FUSEBOX DECAL REPLACEMENT 9700 (B13R)

NOTICE TO SERVICE CENTERS	
Verify vehicle eligibility by checking warranty bulletin status with SAP or via ONLINE WARRANTY SYSTEM available on Service / Warranty tab of PrevoSt website.	
Model	VIN
Volvo 9700 us/can Model Year : 2014 - 2016	From 3CET2V22X <u>E5164935</u> up to 3CET2V42X <u>G5176275</u> incl.
This bulletin does not necessarily apply to all the above-mentioned vehicles, some vehicles may have been modified before delivery. The owners of the vehicles affected by this bulletin will be advised by a letter indicating the Vehicle Identification Number (VIN) of each vehicle concerned.

FIG. 3 FUSE BOX FIGURE

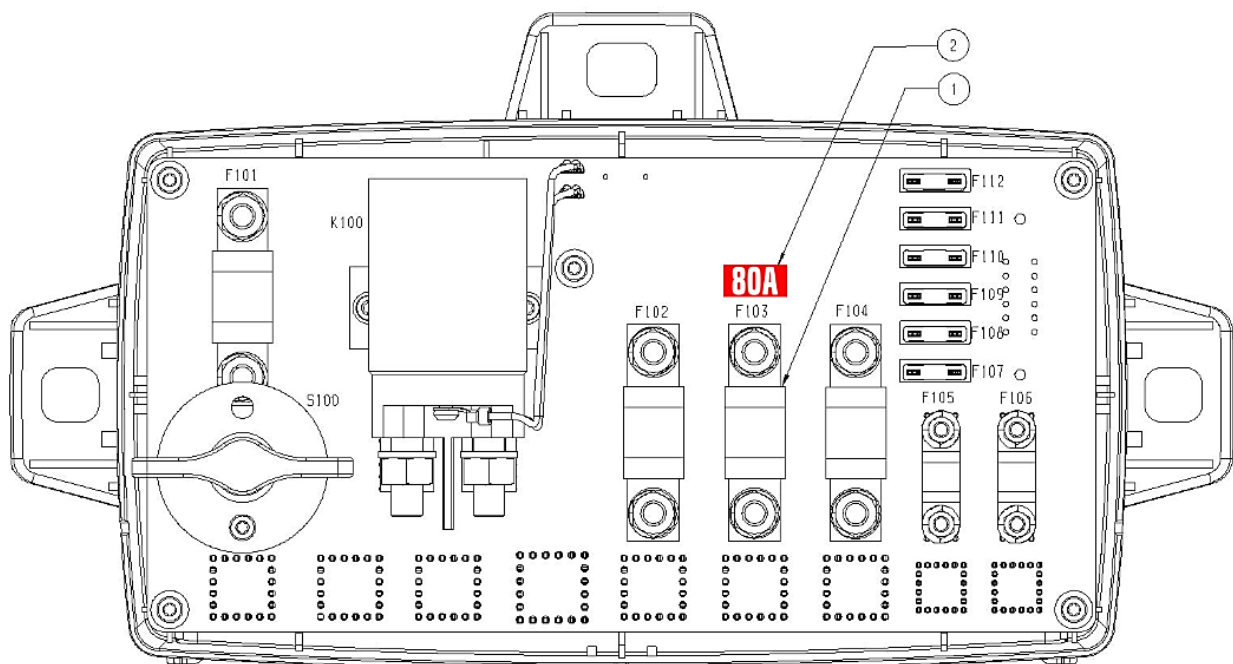
On vehicles affected by this bulletin, the fuse decal at position "F103", inside the front fuse box, indicates incorrect information. **80A** should be read instead of the actual value of 150A.

- 1) Validate that the VIN matches the models involved (see 1st page of document).
- 2) Locate the concerned fuse box and make sure its PN corresponds to the faulty model. (PN 22186411)
- 3) Open the fuse box compartment and install the decal as shown on the image, making sure that the decal location is neat and free of dust or residues (clean adequately if required):

A specific decal must be placed in order to indicate the correct ampere information at position "F103".
